Access Compliance Report

Public Rights-of-Way

(Curb Ramps)

Intersection ID: 53095	Main Street: ALEXANDER_DOWD_DR	Cross Street: DEERFIELD_MANOR_DR	Location: W
ADA ID: A76372CBE7B0	Ramp Type: Perp	Initial Pass/Fail: Fail	Overall Compliance: No
Severity Score: 12.5			
Codes/Mitigation Info/Possible Solution		Field Measurements/Component Compliance

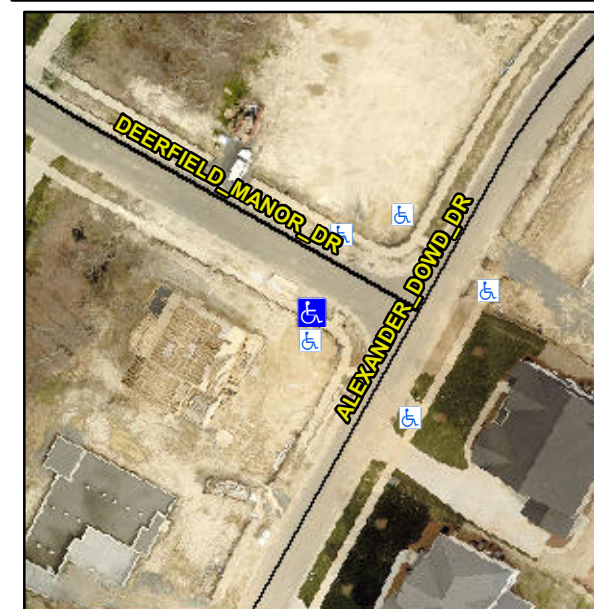
Not Found, R304.5.3

Compliance	Description	Data	Compliance	Description	Data
N/A	Ramp Length (in)	94.0	Yes	Ramp Slope (%)	6.4
Yes	Ramp Width (in)	48.0	No	Ramp XSlope (%)	5.2
N/A	Flare Type LT	N/A	N/A	Flare Type RT	N/A
N/A	Flare Slope LT (%)	N/A	N/A	Flare Slope RT (%)	N/A
N/A	Flare Traversable LT?	N/A	N/A	Flare Traversable RT?	N/A
N/A	Landing Length (in)	N/A	N/A	DWS Provided?	N/A
N/A	Landing Width (in)	N/A	N/A	DWS Contrast?	N/A
N/A	Landing Slope (%)	N/A	N/A	DWS Length (in)	N/A
N/A	Landing X Slope (%)	N/A	N/A	DWS Full Width?	N/A
N/A	Landing Curb? (Y/N)	N/A	N/A	DWS Offset (in)	N/A
N/A	Shared Landing?	N/A			
N/A	Gutter Ponding?	N/A	N/A	Gutter Slope (%)	N/A
N/A	Gutter Lip Ht (in)	N/A	N/A	Gutter X Slope (%)	N/A
N/A	Painted X Walk1?	No	N/A	Painted X Walk2?	N/A
	X Walk 1 Direction	To NE		X Walk 2 Direction	N/A
N/A	X Walk 1 Width (in)	N/A	N/A	X Walk 2 Width (in)	N/A
	X Walk 1 Slope (%)	4.4		X Walk 2 Slope (%)	N/A
	X Walk 1 X Slope (%)	0.7		X Walk 2 X Slope (%)	N/A

Remove & Replace Entire Ramp.
